MLS 27-A (RTU #138) EMERGENCY GENERATOR REPLACEMENT FOR

MANATEE COUNTY, FLORIDA COUNTY PROJECT NUMBER: 6022289

ADDENDUM 1 - ATS REPLACEMENT TDT 1-15-16 NO. DESCRIPTION BY DATE

E-2

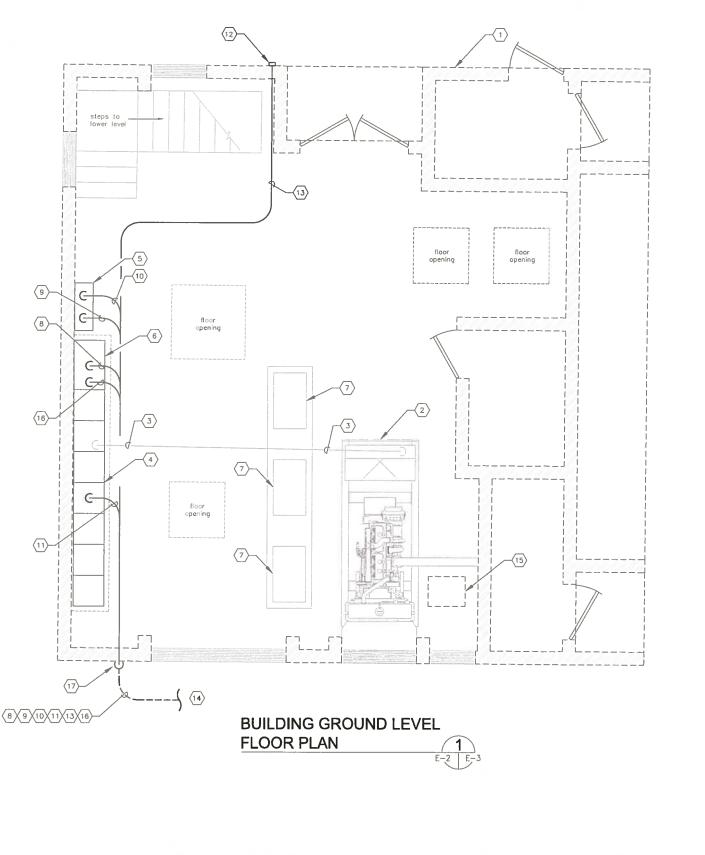
- 4 EXISTING MOTOR CONTROL CENTER (MCC) FOR LIFT STATION 27A. REFER TO SHEET E-5 FOR MCC ELEVATION AND WORK REQUIRED.
- 5 EXISTING TRANSFER SWITCH FOR LIFT STATION 27A TO BE REPLCED. REFER TO SHEET E-5 FOR TRANSFER SWITCH ELEVATION AND WORK REQUIRED.

LIFT STATION 27A MCC ELEVATON

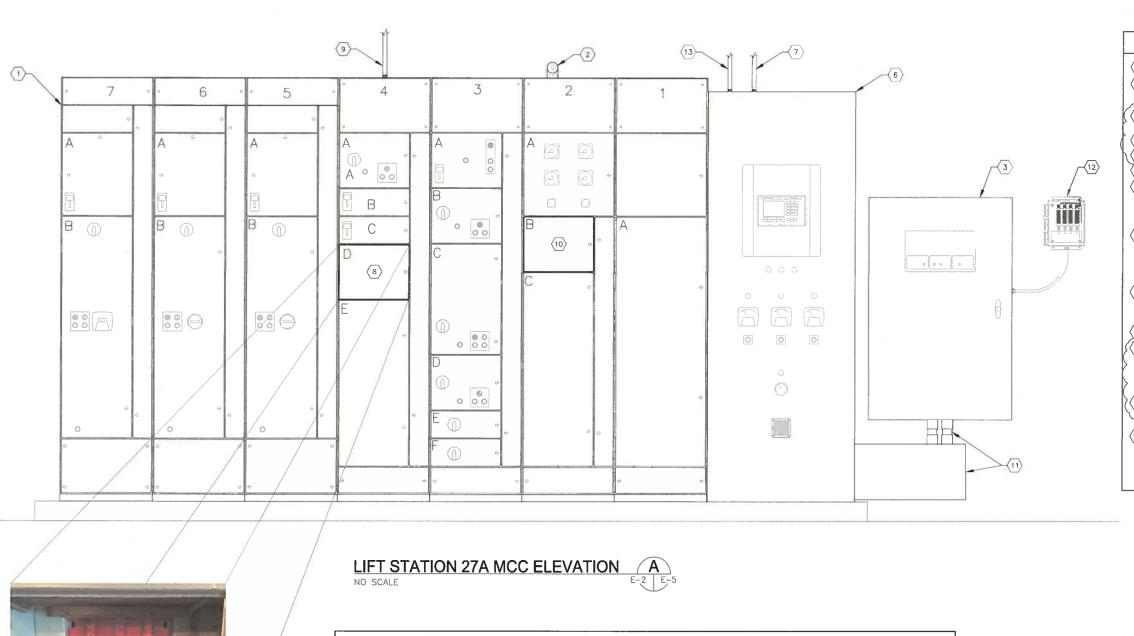
- 3 EXISTING 400A, 480V, 3-POLE, S/N TRANSFER SWITCH TO BE REPLACED. AREFER TO SHEET E-7 FOR DETAILS.
- $\overline{\left\langle 4\right\rangle }$ NOTE REMOVED.

- 5 NOTE REMOVED.
- 6 EXISTING PLC CONTROL CABINET.
- PROVIDE AND INSTALL 8-#12 THWN CU + 1-#12 THWN CU GND IN 3/4" CONDUIT. FIELD ROUTE CONDUIT FROM PLC CONTROL CABINET TO NEW GENERATOR FOR SCADA MONITORING OF GENERATOR. 2-#12 FOR GENERATOR RUNNING INDICATION, 2-#12 FOR GENERATOR FAIL INDICATION AND 4-#12

- 10) ALTERNATE SPARE 12" BUCKET IN GE 7700 LINE MCC (AT 2B).
- 11) EXISTING WIREWAY AND CONDUIT USED AS RACEWAY FOR EXISTING EMERGENCY FEEDER CONDUCTORS FROM GENERATOR TO ATS, FOR NORMAL POWER FEEDERS FROM MCC TO ATS AND LOAD FEEDER FROM ATS TO MCC. ALL EXISTING CONDUCTORS SHALL BE REMOVED. CONTRACTOR TO PROVIDE AND INSTALL ALL NEW CONDUCTORS AS REQUIRED. REFER ALSO TO SHEET E-7

- 12 EXISTING SURGE PROTECTION DEVICE (SPD). SPD SHALL RECONNECTED TO NEW ATS. CONTRACTOR TO PROVIDE NEW CONDUIT/CONDUCTORS (TO MATCH EXISTING).
- PROVIDE AND INSTALL 8-#12 THWN CU + 1-#12 THWN CU GND IN 3/4" CONDUIT TO EXISTING PLC CONTROL CABINET FOR SCADA MONITORING OF DAY TANK, 2-#12 DAY TANK LEAK DETECTION ALARM, 2-#12 FOR DAY TANK FUEL LOW LEVEL ALARM, 2-#12 FOR DAY TANK FUEL HIGH LEVEL ALARM AND TYPE WITH ENCLOSURE MANUFACTURER.

LIFT STATION 27A ATS REPLACEMENT DETAILS

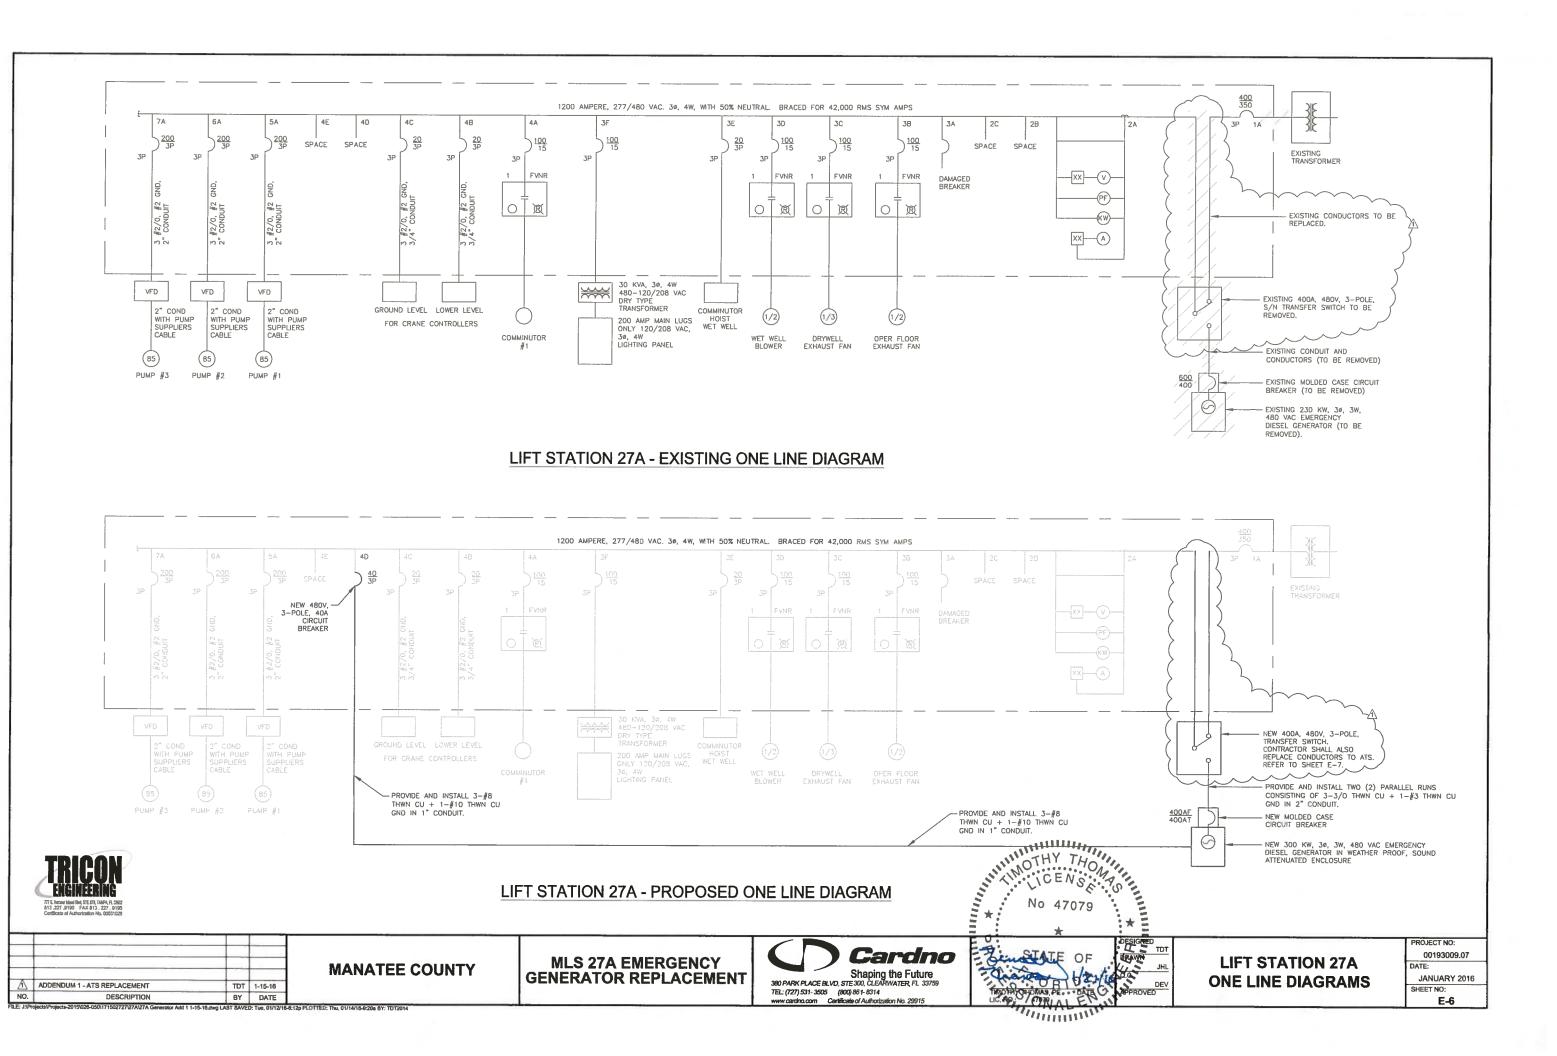
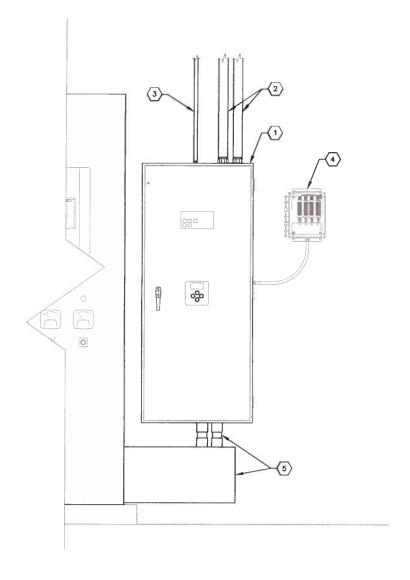
- 1) NEW 400A, 480V, 3-POLE, S/N TRANSFER SWITCH. REFER ALSO TO SPECIFICATIONS. NEW TRANSFER SWITCH DIMENSIONS ARE APPROXIMATELY 24"W x 56"H x 15"D.
- 2) PROVIDE AND INSTALL TWO (2) PARALLEL RUNS CONSISTING OF 3-3/0 THWN CU + 1-#3 THWN CU GND IN 2" CONDUIT. FIELD ROUTE CONDUIT FROM NEW TRANSFER SWITCH TO NEW GENERATOR FOR 480V STANDBY POWER FEEDER
- PROVIDE AND INSTALL 4-#12 THWN CU + 1-#12 THWN CU GND IN 3/4"
 CONDUIT. FIELD ROUTE CONDUIT FROM NEW TRANSFER SWITCH TO NEW
 GENERATOR FOR GENERATOR START SIGNAL CONTRACTOR TO
 COORDINATE/VERIFY GENERATOR STARTER CONTROL REQUIREMENTS WITH
 GENERATOR AND TRANSFER SWITCH MANUFACTURERS.
- EXISTING SURGE PROTECTION DEVICE (SPD), SPD SHALL RECONNECTED TO NEW ATS. CONTRACTOR TO PROVIDE NEW CONDUIT/CONDUCTORS (TO MATCH
- (5) EXISTING WIREWAY AND CONDUIT USED AS RACEWAY FOR EXISTING CONDUCTORS. CONTRACTOR SHALL -

REMOVE EXISTING NORMAL POWER CONDUCTORS FROM EXISTING MAIN CIRCUIT BREAKER TO EXISTING ATS AND REPLACE WITH TWO (2) PARALLEL RUNS CONSISTING OF 3-3/0 THWN CU + + 1-3/0 THWN CU NEUTRAL + $1-\frac{4}{3}$ 3 THWN CU GND

REMOVE EXISTING ATS LOAD SIDE CONDUCTORS TO MCC AND REPLACE WITH TWO (2) PARALLEL RUNS CONSISTING OF 3-3/0 THWN CU.
